Access Compliance Report

Public Rights-of-Way

(Curb Ramps)

Intersection ID: 32279	Main Street: AUBURN_TOP_LN	Cross Street: CAPRICORN_LN	Location:	E
ADA ID: 74AA74D718FE	Ramp Type: PerpDiag	Initial Pass/Fail: Fail	Overall Compliance: No	Severity Score: 25
Codes/Mitigation Info/Possible Solution		Field Measurements/Component Compliance

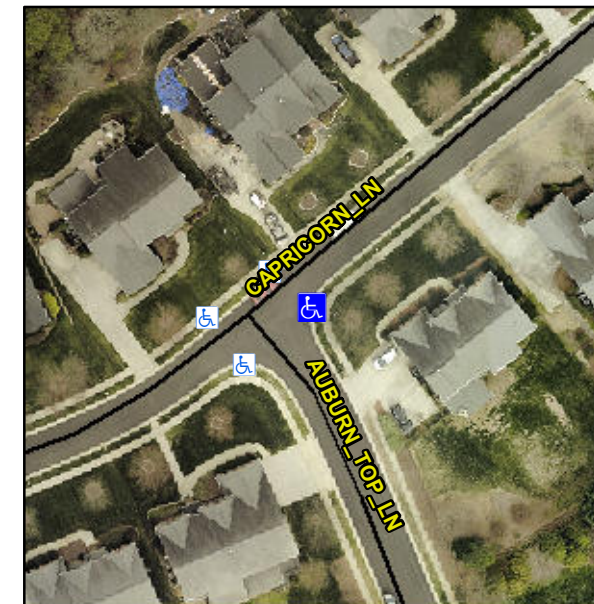
Not Found, R304.5.3

Compliance	Description	Data	Compliance	Description	Data
N/A	Ramp Length (in)	48.0	Yes	Ramp Slope (%)	6.8
Yes	Ramp Width (in)	58.5	No	Ramp XSlope (%)	7.4
N/A	Flare Type LT	N/A	N/A	Flare Type RT	N/A
N/A	Flare Slope LT (%)	N/A	N/A	Flare Slope RT (%)	N/A
N/A	Flare Traversable LT?	N/A	N/A	Flare Traversable RT?	N/A
N/A	Landing Length (in)	N/A	N/A	DWS Provided?	N/A
N/A	Landing Width (in)	N/A	N/A	DWS Contrast?	N/A
N/A	Landing Slope (%)	N/A	N/A	DWS Length (in)	N/A
N/A	Landing X Slope (%)	N/A	N/A	DWS Full Width?	N/A
N/A	Landing Curb? (Y/N)	N/A	N/A	DWS Offset (in)	N/A
N/A	Shared Landing?	N/A			
N/A	Gutter Ponding?	N/A	N/A	Gutter Slope (%)	N/A
N/A	Gutter Lip Ht (in)	N/A	N/A	Gutter X Slope (%)	N/A
N/A	Painted X Walk1?	No	N/A	Painted X Walk2?	No
	X Walk 1 Direction	To NW		X Walk 2 Direction	To SW
N/A	X Walk 1 Width (in)	N/A	N/A	X Walk 2 Width (in)	N/A
	X Walk 1 Slope (%)	2.4		X Walk 2 Slope (%)	7.8
	X Walk 1 X Slope (%)	5.7		X Walk 2 X Slope (%)	2.3

Remove & Replace Curb Ramp With Two New Directional Ramps or Equivalent.
